**Four-Forest Restoration Initiative, Coconino and Kaibab National
Forests Environmental Impact Statement
August 2011 Scoping Content Analysis – Phase 2
Scoping Report, June 10, 2012**

Table 1. August 2011 Scoping Comment Index

Figure 1. Weather Station Data Averages on the Tusayan District (Kaibab NF) 2001 to 2011

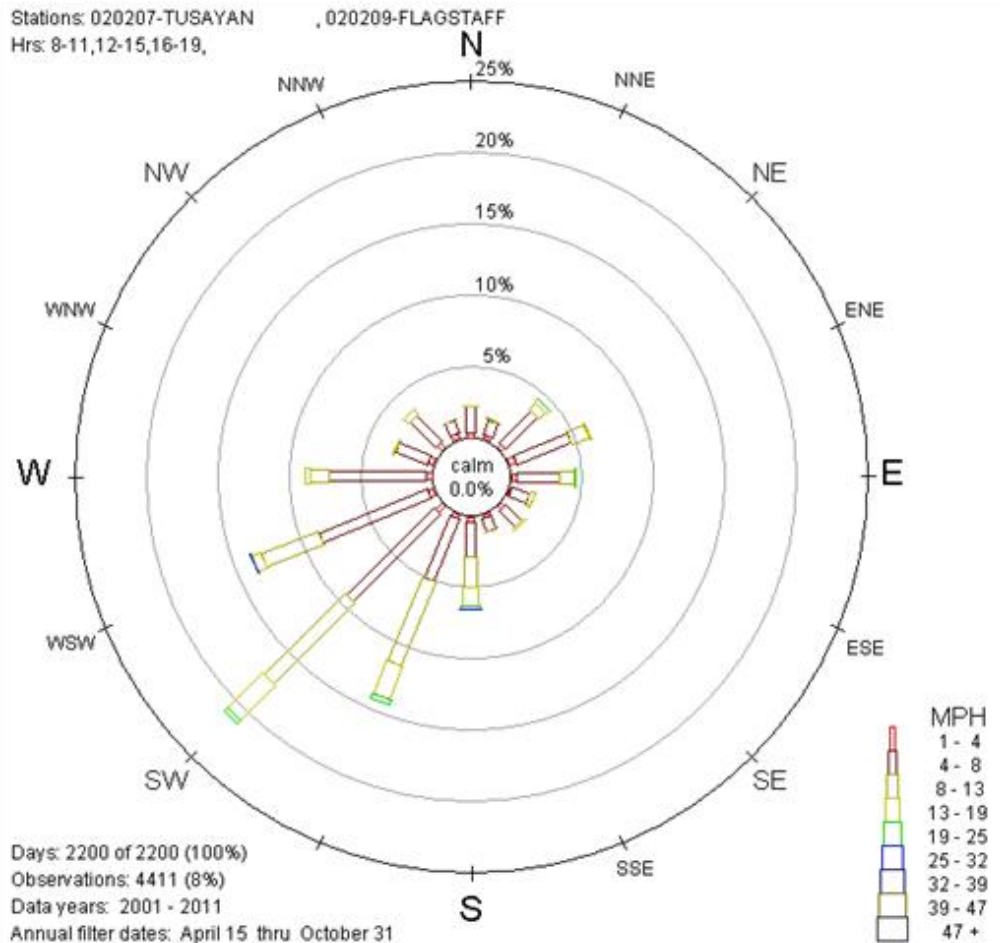
Comment 22-2: On the second page of the Coconino National Forest Handout, under the topic of “What about the pollution from the smoke”. You state “Smoke produced on a prescribed burn occurs only for the duration of that burn”. This is not true, since the acrid smoke and respiratory irritants last from morning to dusk and then some depending on wind direction and velocity.

Response: For clarification, the handout referenced was associated with the Coconino, Kaibab, and Prescott National Forests Smoke and Fire Open House hosted at the Sedona City Council Chambers (Sedona, AZ) on August 23, 2011. Smoke is only produced while the fire is burning, but it is likely to linger in low areas when it cools off overnight and there is not sufficient wind to disperse it. We have included excerpts from the air quality report that is under development which helps frame smoke dispersal:

Topography and weather patterns determine the extent to which airborne particulate matter accumulates within local airsheds. Diurnal temperature changes affect how pollutants in the region are dispersed. Meteorological conditions also limit how much smoke the airshed can absorb at any point in time without violating National Ambient Air Quality Standards (NAAQS), or visibility thresholds. During the warmest days and seasons of the year, air is heated at the surface, and rises, lifting smoke up to heights where transport winds carry it away and disperse it during the daily burn periods. Winds in the project area are predominantly from the south, southwest, and west (Figure 1) and, as such, during daytime hours, fire activities within the 4FRI treatment area are most likely to affect smoke sensitive receptors to the north, northeast, and east of fire locations. The best ‘windows’ for smoke dispersal are when the atmosphere is unstable, allowing smoke to rise up high and disperse. These conditions, when combined with low fuel moistures and high fuel loading, can also lead to undesirable fire behavior and effects. The best dispersal days are often too extreme for prescribed fire. Winds often become calm overnight, and topographic effects then dominate smoke movement. The earth surface cools and the cooling air then flows downhill, carrying smoke from smoldering fuels (duff, needles, dead/down wood), which will often ‘pool’ in low lying areas until the air warms again the next day. Nighttime settling of residual smoke from fires generates as many concerns and complaints of nuisance smoke as daytime smoke. “Nuisance Smoke” is defined in the State Implementation Plan (required by the ADEQ to facilitate managing air quality impacts) as “Amounts of smoke in the ambient air which interfere with a right or privilege common to members of the public, including the use or enjoyment of public or private resources” (Arizona State Implementation Plan Appendix A-10, pg. 35)

During the winter, weather conditions can trap emissions in a layer of cold surface air (inversion). Under winter conditions and inversions, particulates can be trapped close the surface in local airsheds including Flagstaff, Williams, and the Verde Valley. Visibility is also an air quality consideration. Visibility tends to be lowest in the summer due to regional haze and smoke from fires.

Figure 2. Maintenance and Non-attainment Areas by Airshed and Vicinity to Class 1 Airsheds

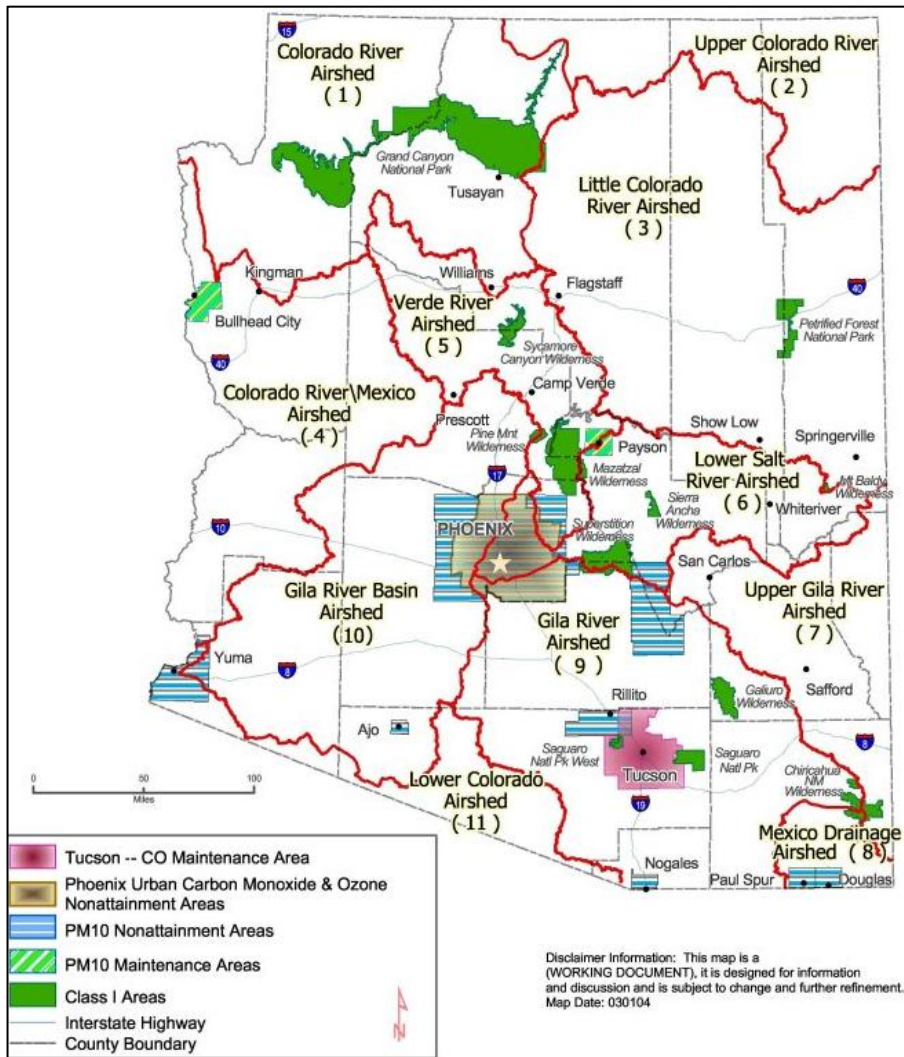
Comment 22-4: I don't believe dilution is the solution as opined by one Forest Service representative, especially with potent carcinogens and particulate carbon. To suggest that people, who are suffering, physically go somewhere else is negligent, since burns occur frequently and the smoke spreads widely and can linger in pockets and the toxic agents are not always discernable by smell.

Response: The ADEQ monitors air quality for compliance with the NAAQS and has monitors set up in the Verde Valley, Flagstaff, and multiple other sites across the state. It is not possible to monitor every acre, or even every 10 acres of land. When there are situations of specific concern, the ADEQ may set up portable monitors. "The following website: <http://www.phoenixvis.net> provides outputs of these monitors. Figure 2 (below) displays airsheds as defined by ADEQ. The 4FRI analysis will identify those airsheds that may have direct, indirect, and cumulative effects associated with project prescribed fire activities.

Figure 3. Projected Emissions from Wildfire With and Without Mechanical Treatment

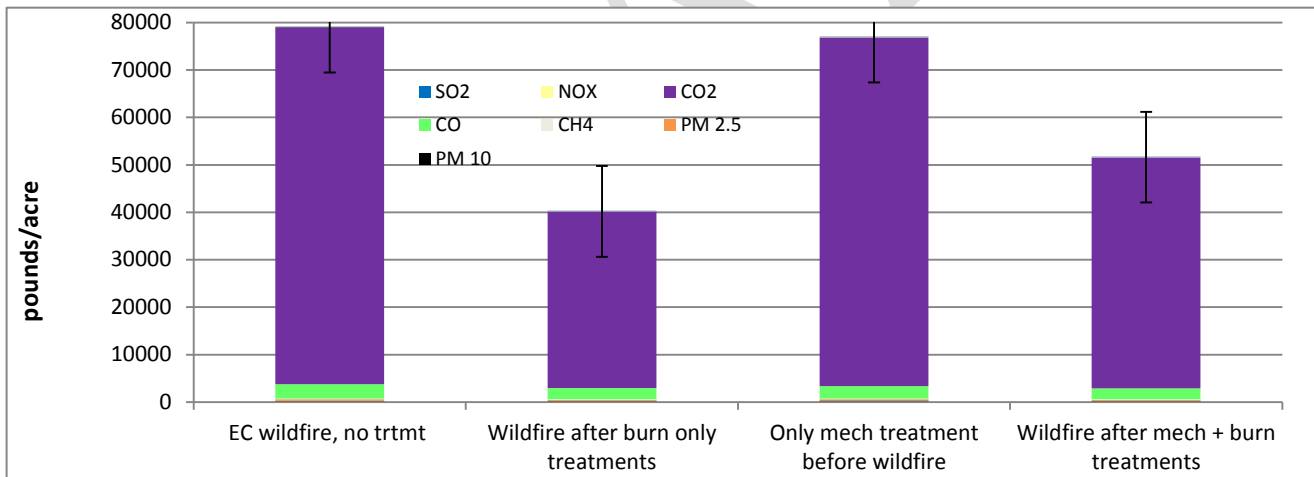
Comment 24-4 (Cara 7-4): I urge the Forest Service to accept a somewhat less ecologically perfect scenario for our Northern Arizona forests through widespread logging and grazing of goats and cattle in order to protect our citizens from being forced to breathe these radioactive isotopes. Many municipal, state and Federal land managers have already successfully utilized goat grazing to remove brush fuels, including our own Prescott National Forest. I would like to see a minimum of 10,000 goats in the 4FRI forests 365 days per year, preparing the way for

Response: Thank you for your comment. To respond to the issue regarding project-related smoke, design features were developed to reduce the amount of smoke produced from project activities and an alternative that reduces the acres to be treated with prescribed burning was reduced from 587,923 acres (alternative B) to 178,852 acres (alternative D) was developed. Acres that would be burned in this alternative occur mostly in grassland vegetation. The fire ecology, air quality, recreation, and social-economics environmental consequences disclose the potential impacts to air quality, quality of life, local and regional economy, and public health and safety. The indicators used to evaluate the smoke issue are: (1) Quantitative smoke emission modeling and qualitative interpretation to evaluate the potential for smoke within communities that are within or in near proximity to the project, (2) Modeling of principal pollutants including carbon monoxide (CO), nitrogen dioxide (NO₂), particulate matter less than 10 microns in size (PM 10), particulate matter less than 2.5 microns in size (PM 2.5), ozone (O₂), and sulfur dioxide (SO₂) pollutants that pose potential health hazards to evaluate compliance with the Clean Air Act as regulated by ADEQ, and, (3) Social and economic evaluation of impacts to quality of life and tourism.

Regarding your concern with emissions: emissions from surface fuels burning in a wildfire within stands that have been thinned but not burned are not statistically different from those from stands in their existing condition (Figure 3). Specific to this analysis, figure 3 displays the anticipated differences in wildfire-related emissions predicted from surface fuels under different treatment scenarios and identical fire conditions. The graph displays the pounds-per-acre of wildfire emissions expected from scenarios including (1) existing condition (no action - no mechanical or prescribed fire treatment), (2) treatments limited to two prescribed fires (burn-only) conducted within a 10-year period, (3) mechanical treatment-only (no prescribed fire), and, (4) mechanical treatment with two prescribed fires conducted within a 10-year period. Please note, Figure 3 does not display the effects of the canopy fuels which, in the initial flame front, are a significant producer of emissions. However, those emissions are generally of shorter duration since they are produced as the flaming front passes by. Little canopy fuel is burned in prescribed fire. Much of the lingering smoke comes from duff, coarse woody debris, stumps, and other fuels that may smolder.
